DC Protection for the IGBT Power Amp

E. Potters

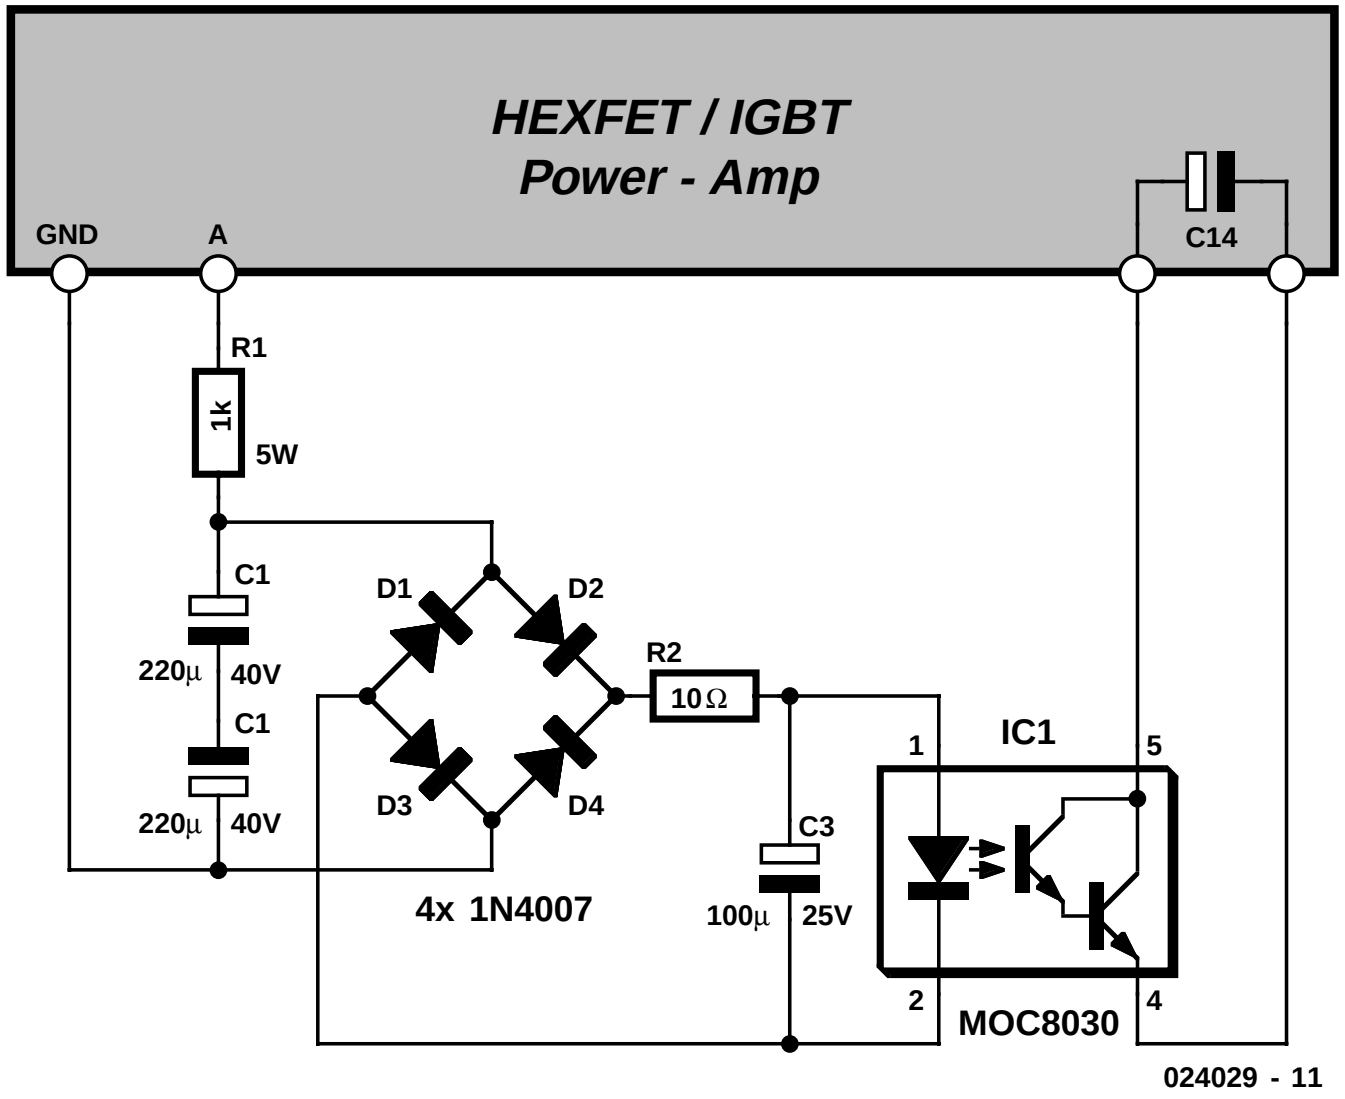
The accompanying schematic diagram shows the simplicity the necessary extension, which naturally can also be used with the Hexfet Power AMP described in the November 1993 issue (which is identical in terms of overall design). All that is involved is an optoisolator that monitors output terminal A of the amplifier via a bridge rectifier and series resistor, and whose output is connected in parallel with C14 in the relay control stage. This circuit can be used for all amplifiers up to a DC voltage of 70 V. For higher voltages, the value of R1 must be modified. When a voltage of approximately 2 V_{DC} is present at the input, the phototransistor in IC1 starts to conduct, causing C14 in the amplifier to discharge and disconnect the loudspeaker from the amplifier output by releasing the relay.

If you want to replace the MOC8030 by a different type, be sure to use a Darlington type (or fit an additional transistor) on account of the dynamic range. Also, pay attention to the maximum diode current, which is 80 mA for the MOC8030.
